Re:  
UBC 20/2016 DA  
Unauthorized Works  
5 Barrabooka St Clontarf

#### LETTER OF OBJECTION

Sketch A: extract from DA drawings showing 1.8m high front fence. Southern 1.8m high fence to be reduced to 1m.

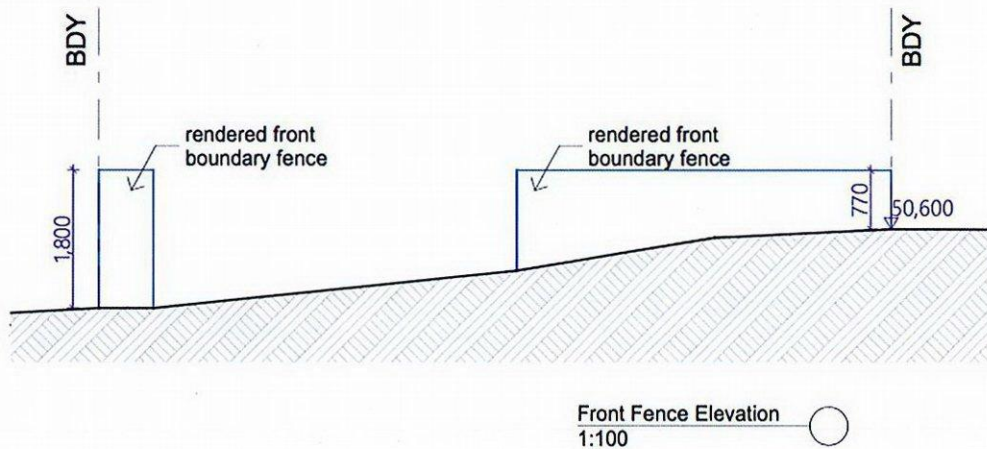
I am concerned that the Front Fence elevation does not accord with MDCP. I request Council impose a condition to limit the maximum height of the Front Fence to be 1m high. The current height of 1.8m southern pier is completely out of character with the streetscape. Council will note that most properties have no front fence, allowing for the natural vegetation to run through these areas. Preferably the front fence should be deleted. It is also noted that no approval is sort under this application for any front gate to the front boundary, and I ask Council to impose a Condition requiring a new DA to be submitted if a gate is to be proposed.
